14 March 2023

**RESPONSE TO REQUEST FOR FURTHER INFORMATION – ENERGY FARMS LIMITED –
MARTON SOLAR FARM PROJECT**

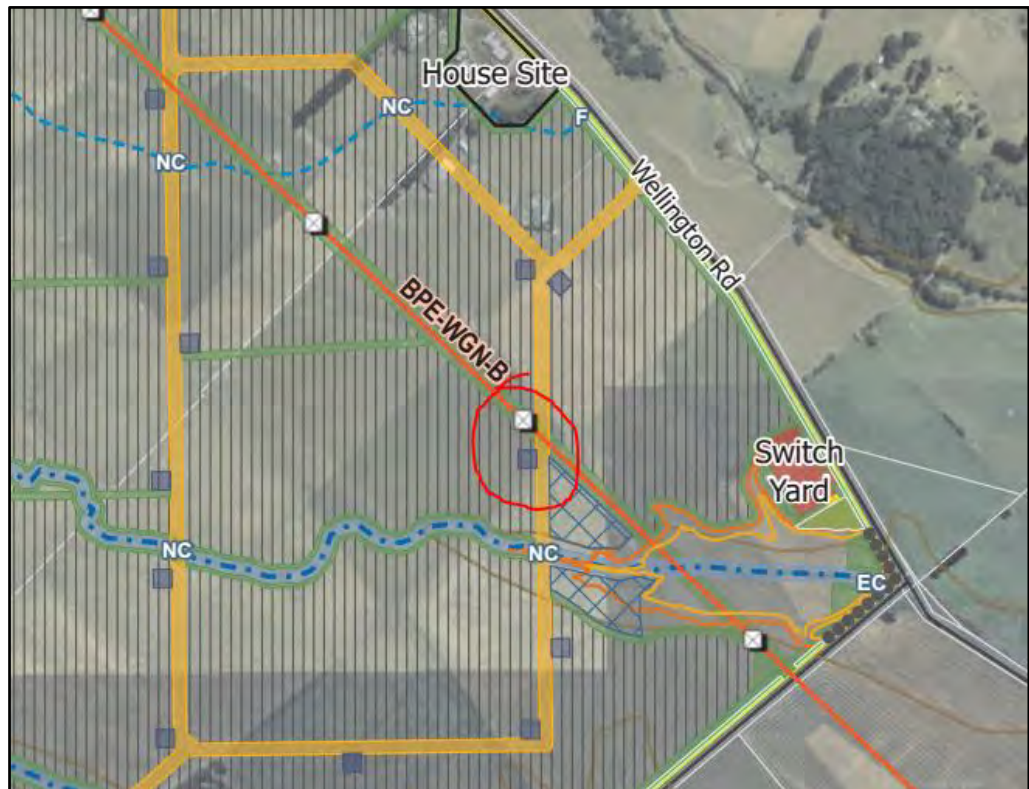
11. There are four rules in the RDP that relate to earthworks/structures in proximity to National grid lines/structures. These are addressed below. The proposal does not require consent under any of these rules.
 - B1.13-1 requires that earthworks within 12 metres of the outer edge of a National grid structure comply with the New Zealand Code of Practice for Electrical Safe Distances (NZECP34:2001). Some earthworks may be required within this distance to form an internal access road. The relevant area is

identified below (white box with a cross is a structure, thick orange line is a road). Discussions with Beca have confirmed that any associated earthworks will be undertaken to comply with these requirements. The proposal is permitted under this rule.
